**ADDENDUM | 01**  
**Mary C. Howse Elementary School**  
**641 Boot Road, West Chester, PA 19380**  
**BHA Job No. 22-114**

**DATE OF ISSUANCE:**      **November 17, 2023**

1 **EAST ELEVATION - COURTYARD**  
1/8" = 1'-0"

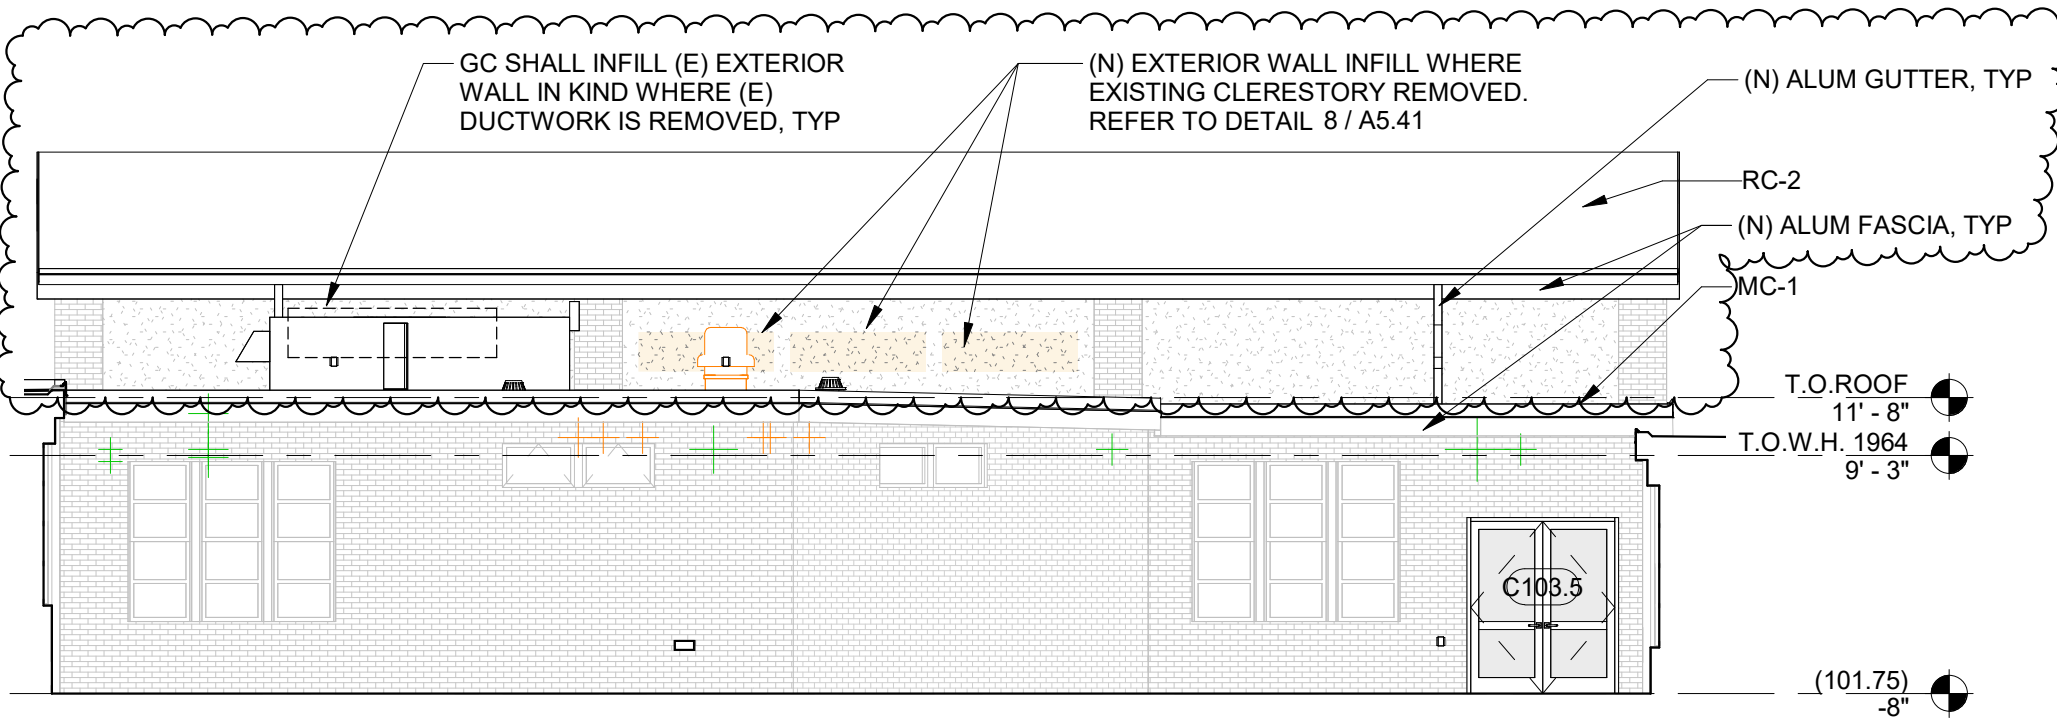
Revise elevation “3” extents to show exterior of existing Library. Refer to SK-3.

## 1 DETAIL - BRICK REPAIR AT COURTYARD

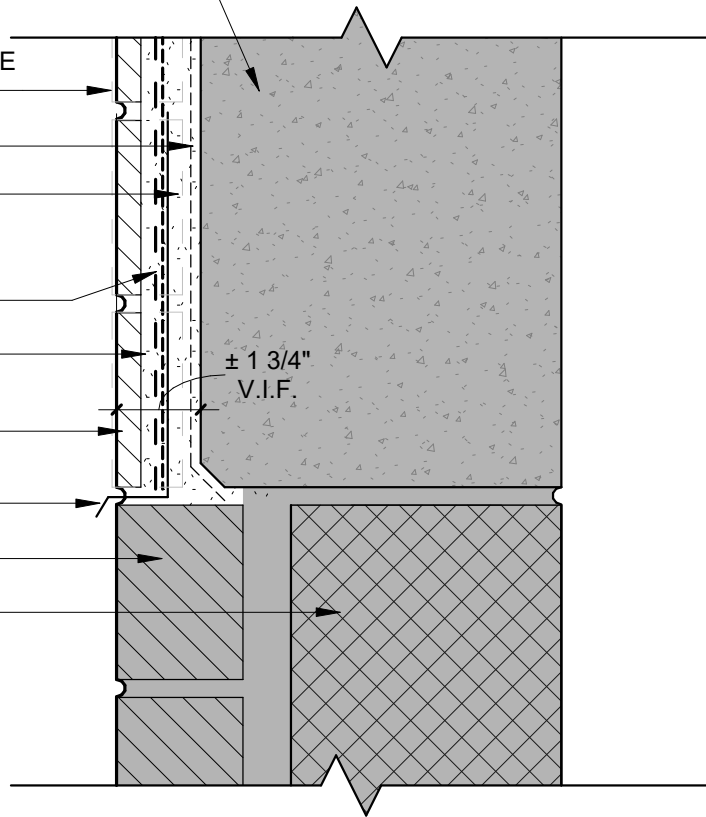
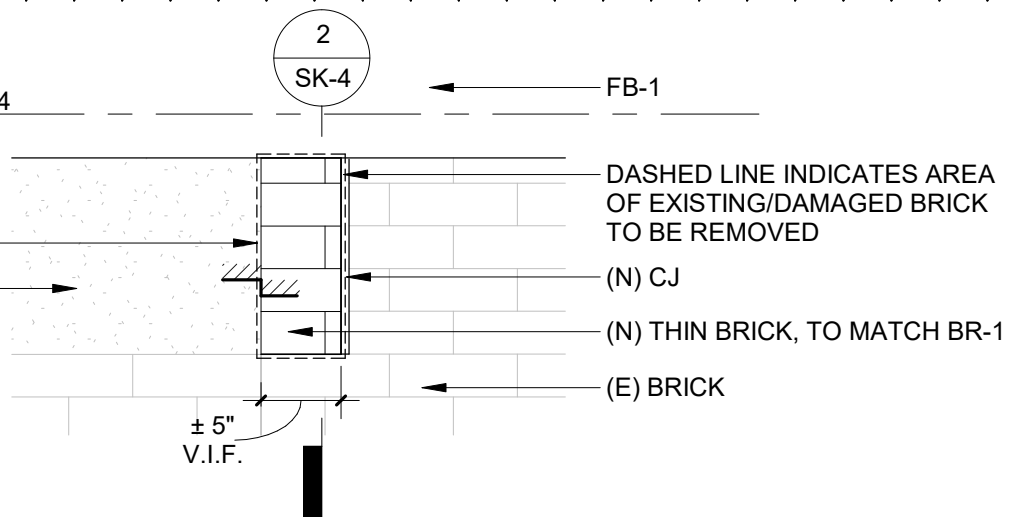
Add notes to remove portions of existing brick at existing concrete lintel in (9) locations. Refer to SK-4 for dimensional extents.
